THIS MODIFICATIONS ADDS THE INTERRUPT SYNCHRONIZER TO ALL CPU BOARDS (P/N 001062) THROUGH REVISION "G". THE INTERRUPT SYNCHRONIZER PREVENTS GENERATION OF A SPURIOUS INTERRUPT VECTOR IF A NEW INTERRUPT OCCURS AT THE INSTANT A VECTOR IS BEING READ DURING AN INTA CYCLE.

APPR. <i>H.G.D.</i>	DATE 7-21-80	<h1>PolyMorphic Systems</h1> <p>460 Ward Drive Santa Barbara Ca 93111 (805) 967-2351</p>
APPR. <i>F.E.A.</i>	DATE 7-21-80	
APPR. -		
CHECK		TITLE MODIFICATION - CPU BOARD INTERRUPT SYNCHRONIZER
WRITTEN BY		NUMBER 130527
		REV <i>E</i>
		SHEET 1 OF 1

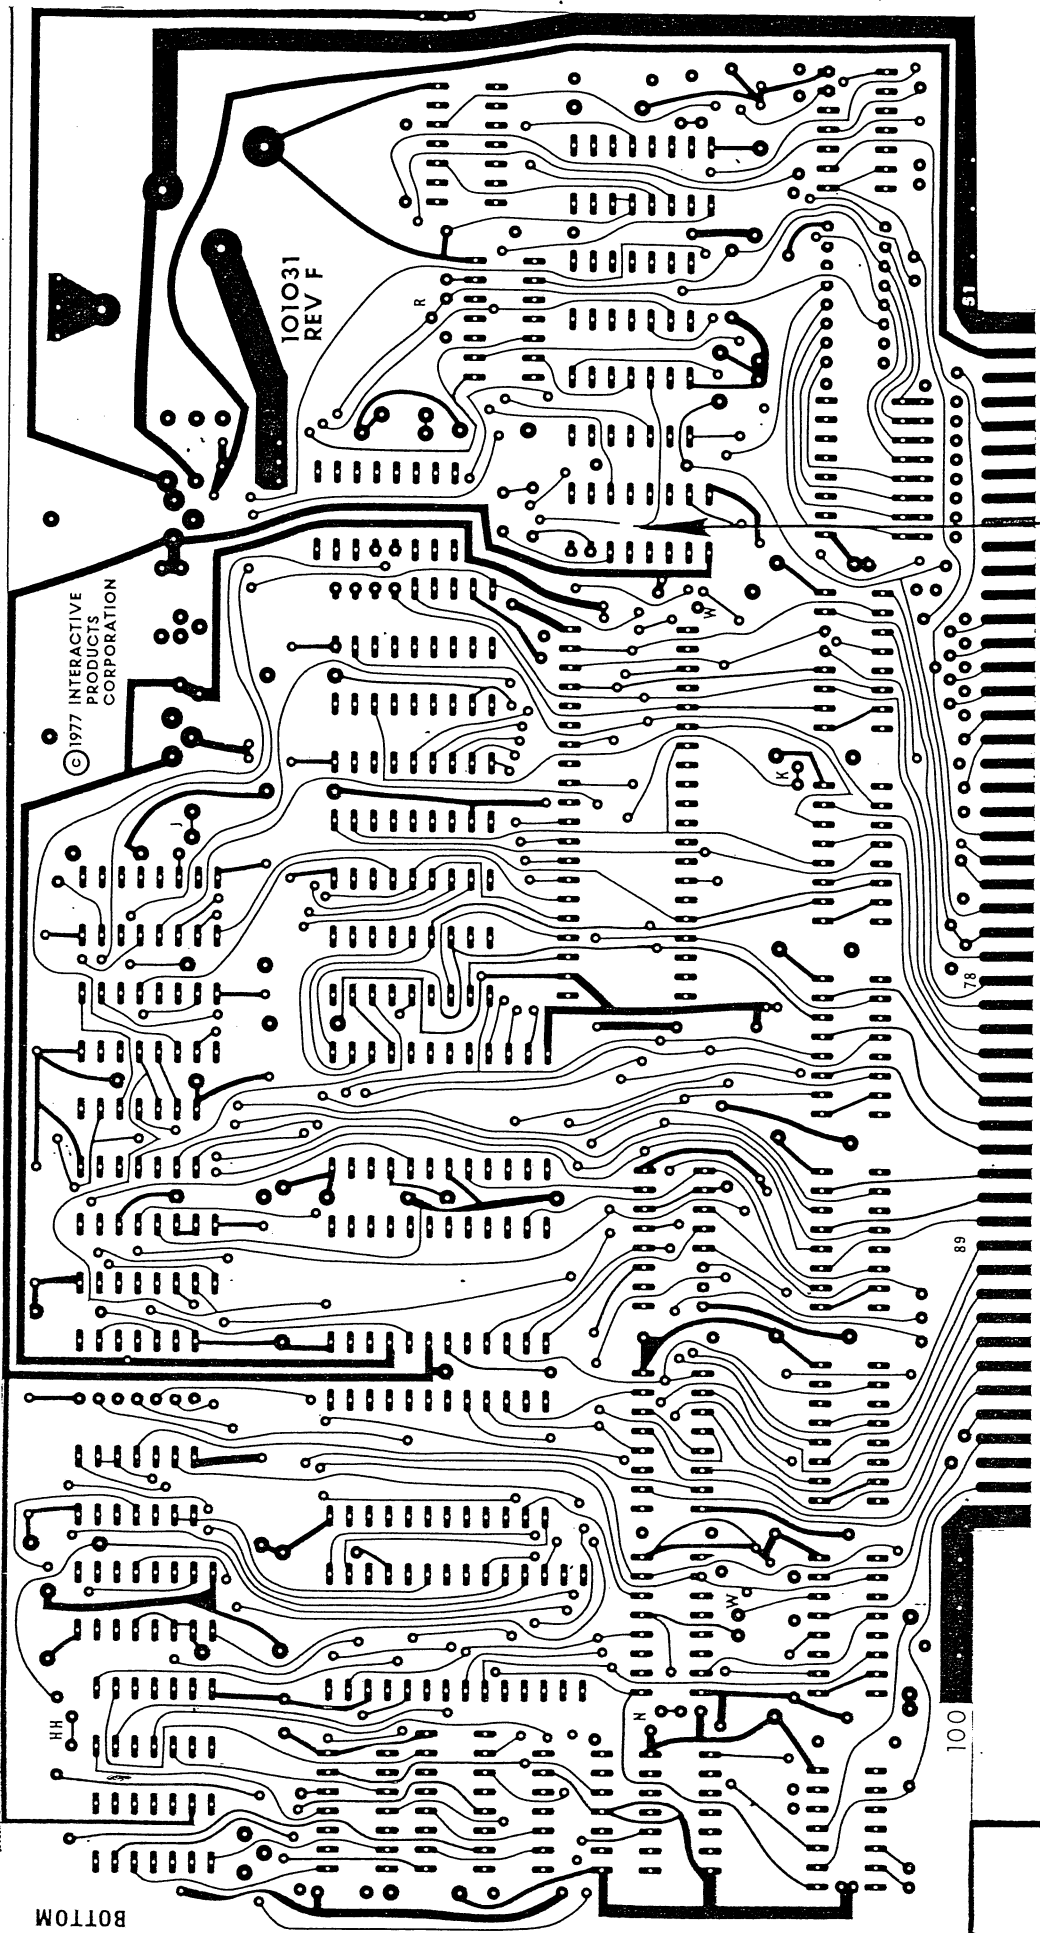
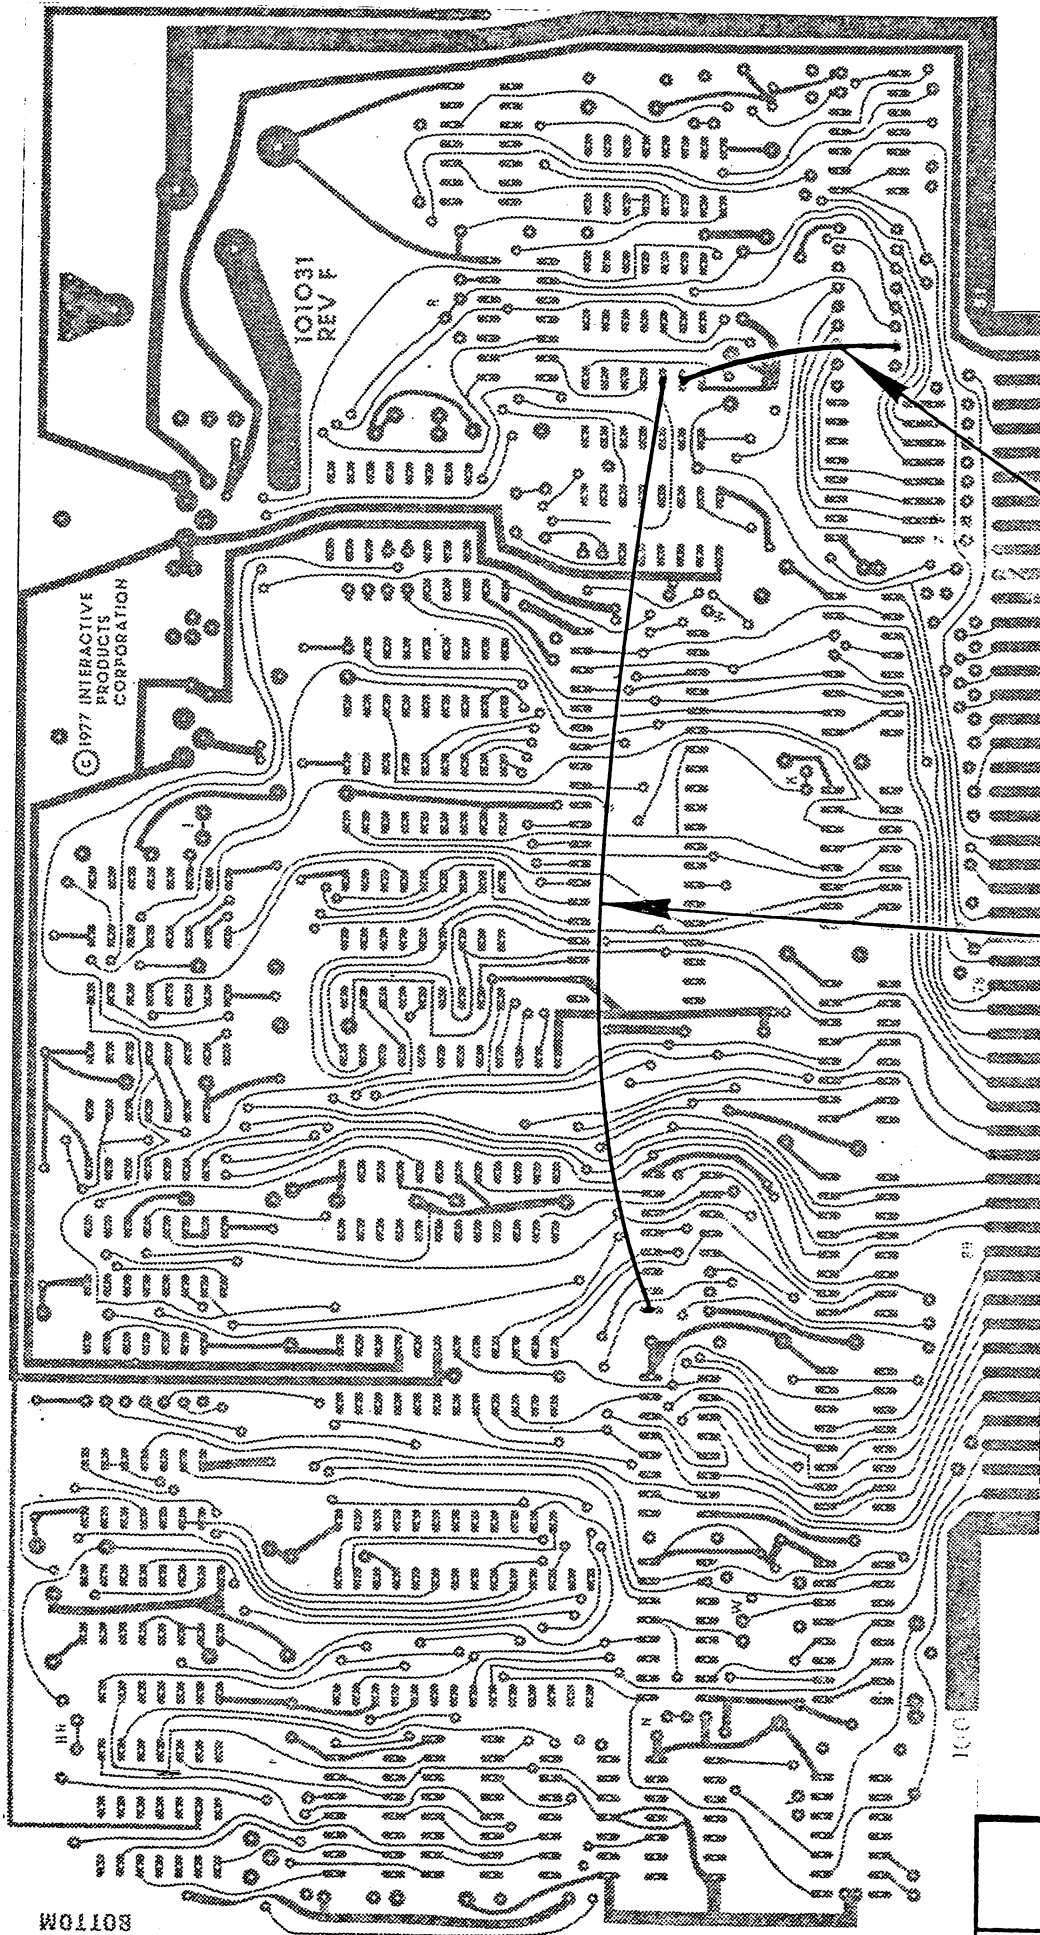
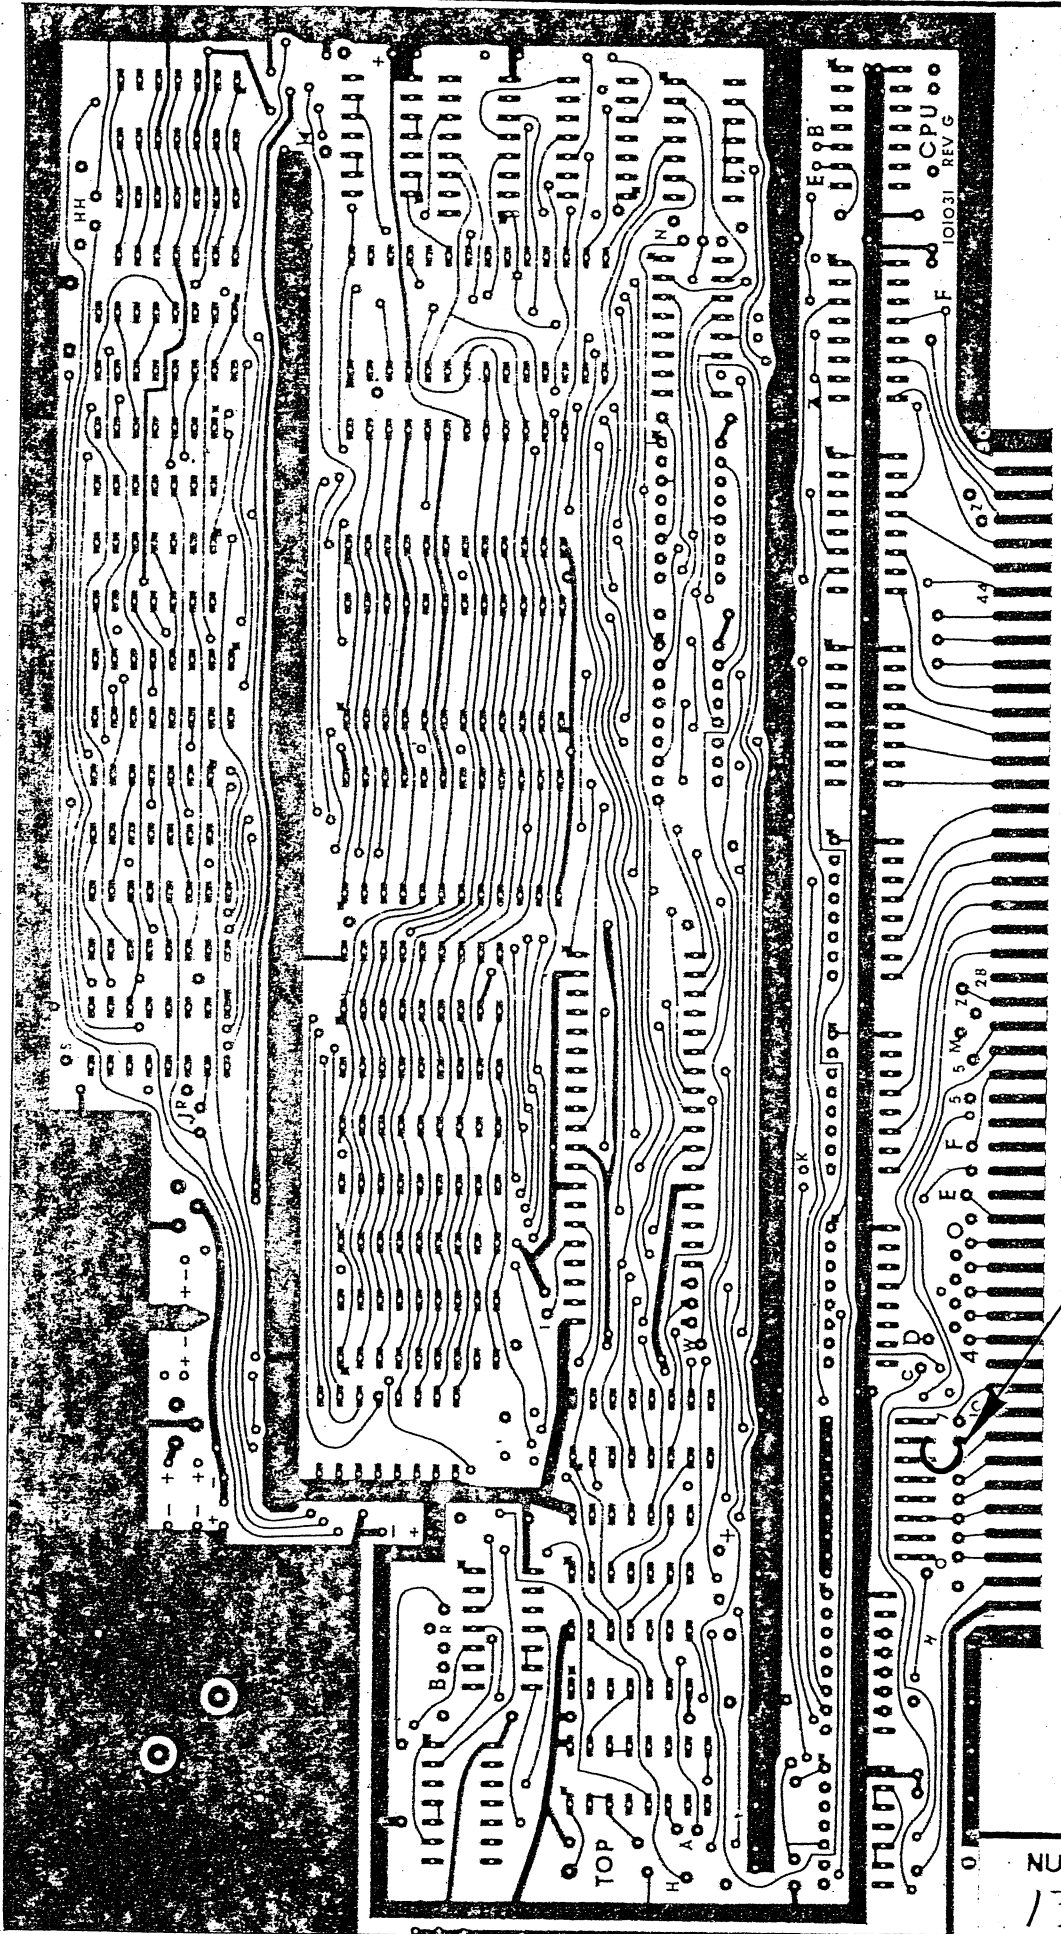
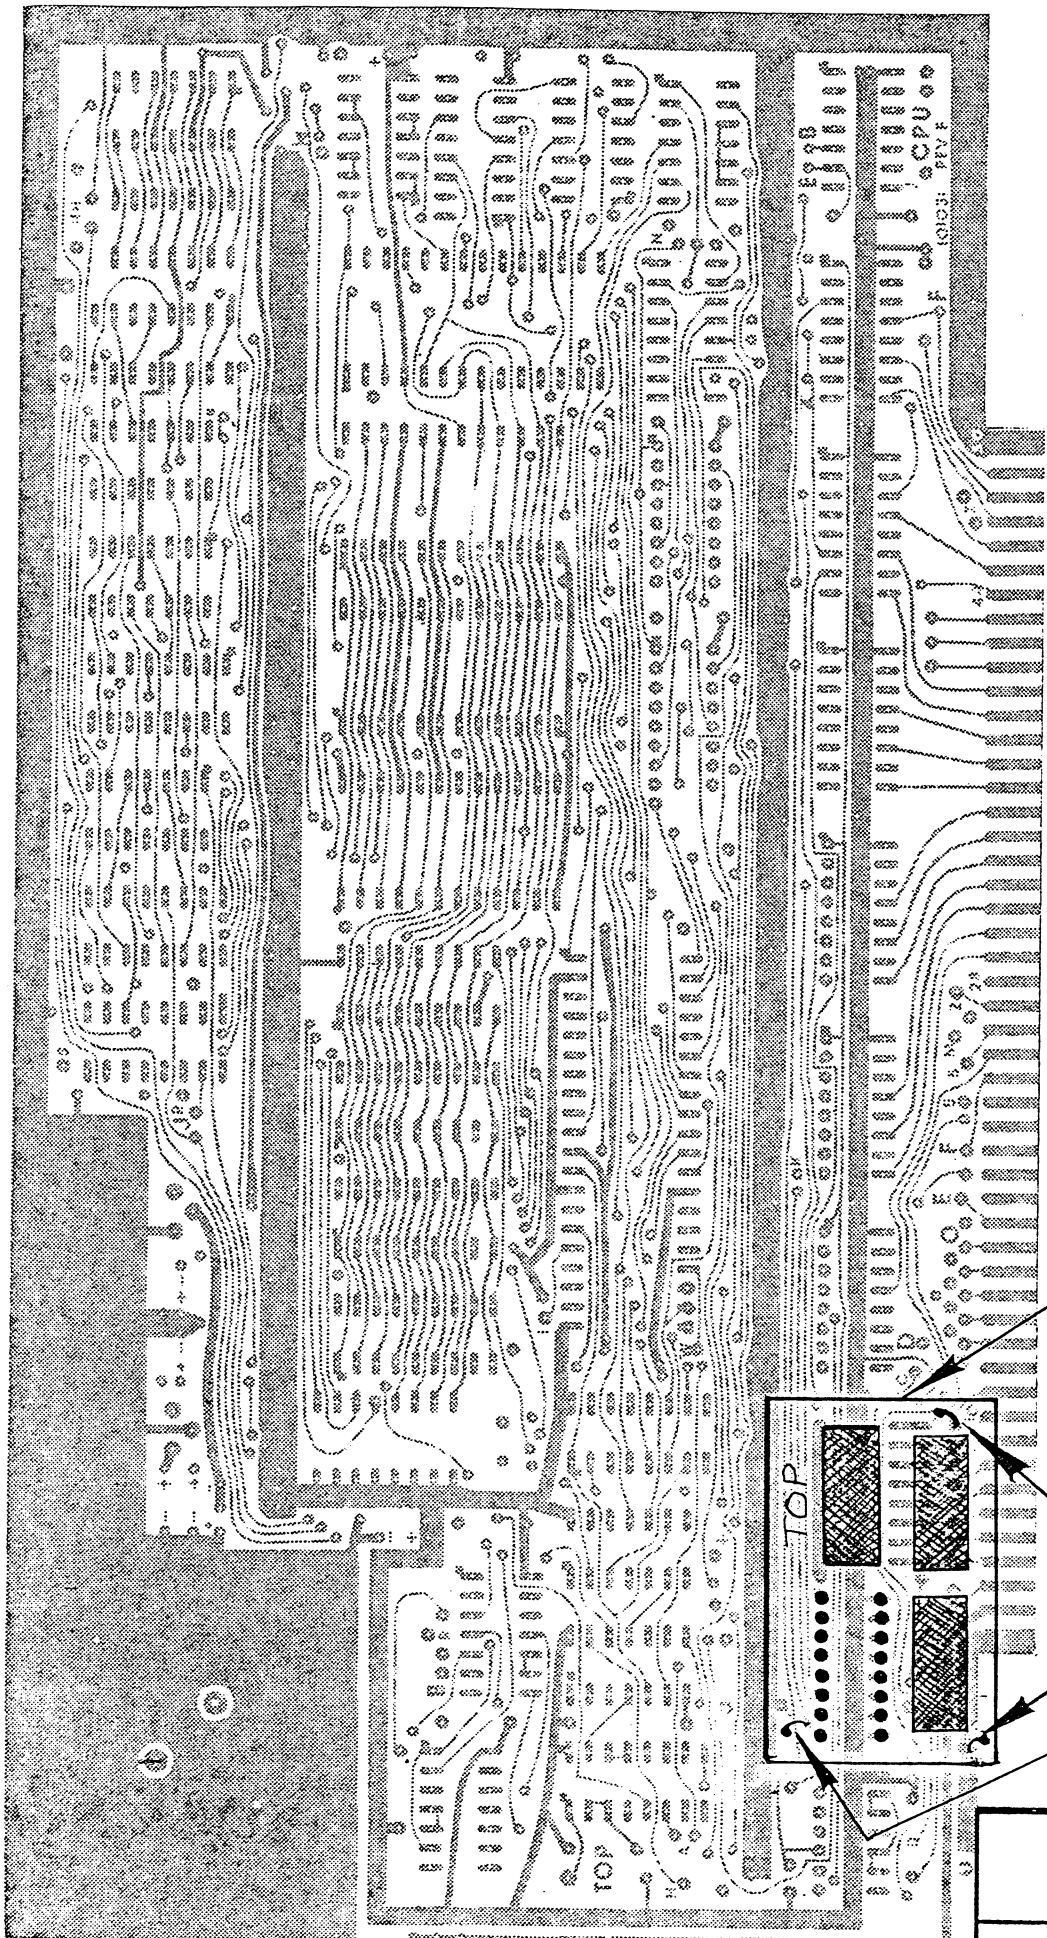
1. CUT TRACE BETWEEN IC12-6 AND IC11-11 ON THE FRONT OF THE BOARD AS SHOWN.
2. CUT TRACE BETWEEN IC12-5 AND THE FEEDTHROUGH NEAR THE TOP OF IC13 ON THE BACK OF THE BOARD AS SHOWN.
3. INSTALL JUMPER BETWEEN IC12-5 AND IC15-1 AS SHOWN USING #28 GREEN KYNAR OR TEFLON COATED WIRE.
4. INSTALL JUMPER BETWEEN IC12-6 AND IC2-15 AS SHOWN USING #28 GREEN KYNAR OR TEFLON COATED WIRE.
5. INSTALL JUMPER AT VI6 AS SHOWN USING #28 GREEN KYNAR OR TEFLON COATED WIRE.
6. REMOVE IC2 (74148)
7. INSTALL 16- PIN SOCKET IF IF NOT PROVIDED ON CARD.
8. INSTALL INTERRUPT SYNCHRONIZER (P/N 005282) 16- PIN PLUG INTO IC2 SOCKET.
9. INSTALL #24 TINNED WIRE JUMPER BETWEEN INTERRUPT SYNCHRONIZER CARD AND CPU BOARD THREE PLACES AS SHOWN. THESE WIRES PROVIDE MECHANICAL SUPPORT FOR THE SYNCHRONIZER CARD. WIRE MUST BE PULLED TIGHT.
